HEATHER ADDITION

WICHITA, SEDGWICK COUNTY, KANSAS

Re: S/D 98-37 -- Final Plat of HEATHER ADDITION

STAFF REPORT

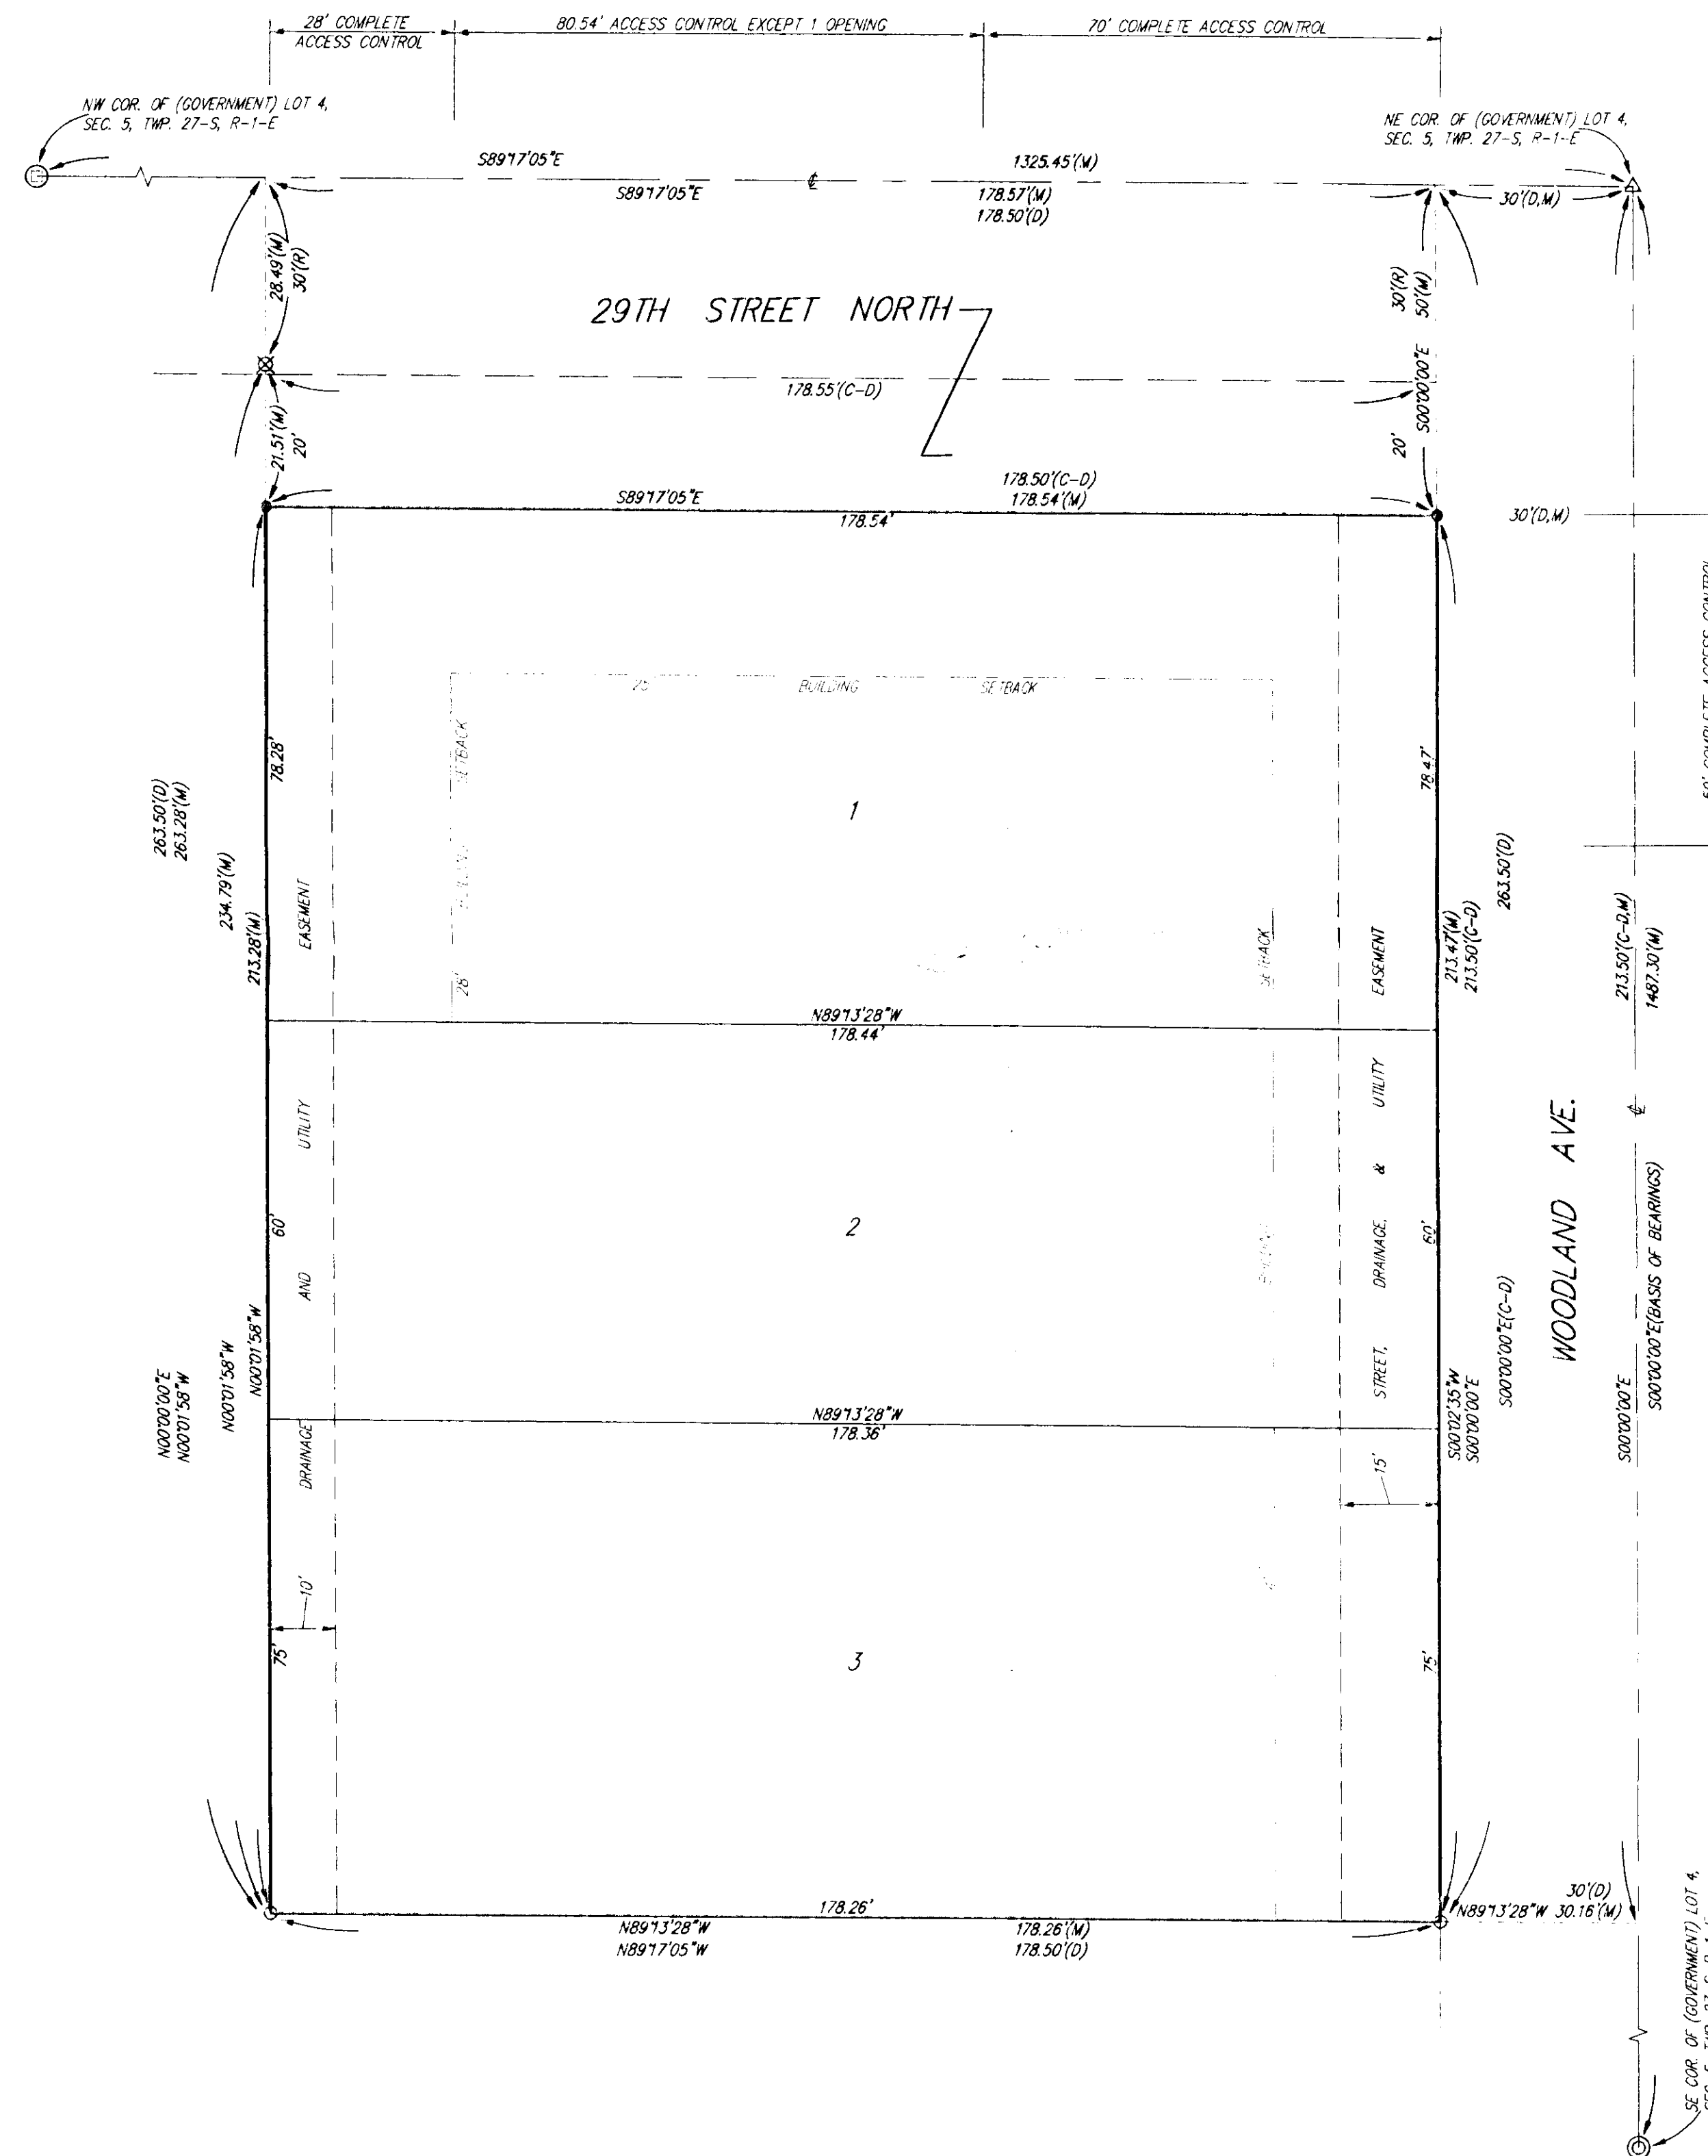
- A. Existing municipal services appear to be available to this site. City Engineering needs to verify if any other guarantees are required. No additional guarantees are needed. Woodland Street contains substandard pavement and an affidavit not to protest future paving to City standards will be required of the applicant.
- B. If improvements are guaranteed by petition, a notarized certificate listing the petitions shall be submitted to the Planning department for recording.
- C. City Engineering needs to comment on the status of the applicant's drainage concept. The drainage plan is approved. A cross-lot drainage agreement is needed or a drainage easement needed to be denoted on the plat along the western line (coinciding with the utility easement).

- D. Traffic Engineering needs to comment on the need for access controls along perimeter streets, and additional right-of-way. Traffic Engineering requests an additional 20-foot of right-of-way along 29th Street North. Complete access control along 29th Street North is required along the westernmost portion of the northern lot and the east 70 feet. Along Woodland, 50 feet of complete access control will be required from the intersection.

- G. The applicant needs to revise the legal description to accurately portray the land being platted. The distances on the drawing are not identical to those in the legal description.

- I. A restrictive covenant shall be submitted limiting the uses of lots 2 to those permitted under the SF-6, Single-Family Residential District.
- J. The final plat tracing shall reference a tie point to a section corner.

A drainage easement has been denoted on the plat as requested.

The additional right-of-way and access controls have been included on the final plat.
